New Elk Mine, C-1981-012, PR5 Adequacy Response

Interoffice Memorandum

**Subject: New Elk Mine (Permit No. C-1981-012)
PR-5**

Figure 1: Screenshot showing records of constructed wells from DWR database with permit category "Residential" (pink dots) overlaid on proposed Map 1 and satellite image

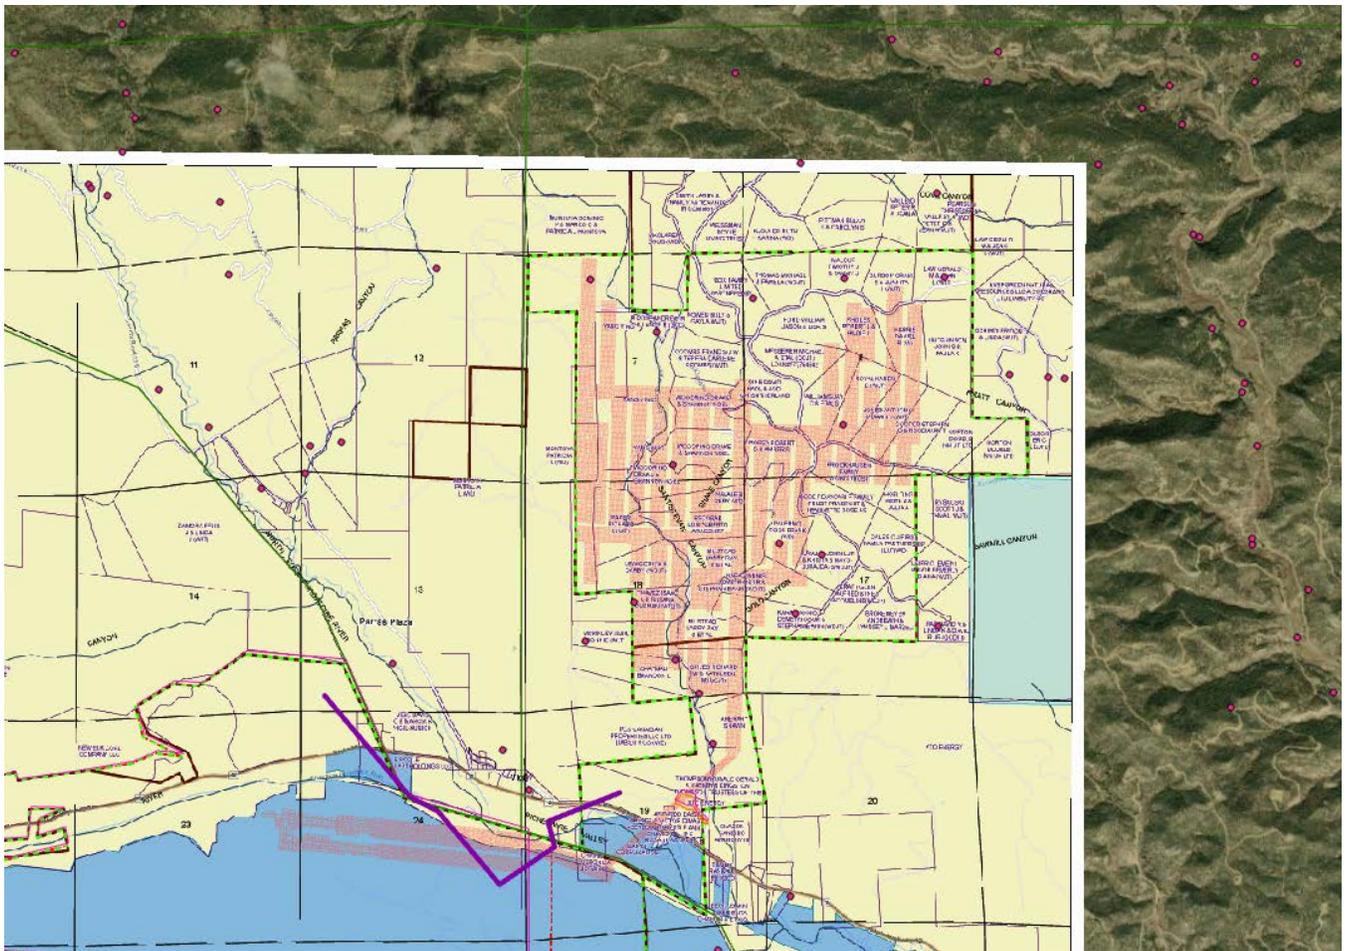
1. Minimal revisions have been proposed to section 2.04.7 of the PAP, however a complete description of the hydrology in the area of the mine is necessary before the consequences of mining can be assessed. It is clear at a cursory review that parts of section 2.04.7 are out of date (for example, Table 10 presents a groundwater user inventory, but the Colorado Division of Water Resources database contains many records of wells that have presumably not been included in the inventory, as is shown in Figure 1).

Please review section 2.04.7 of the PAP and update it as necessary given the expansion to the permit area proposed with PR-5.
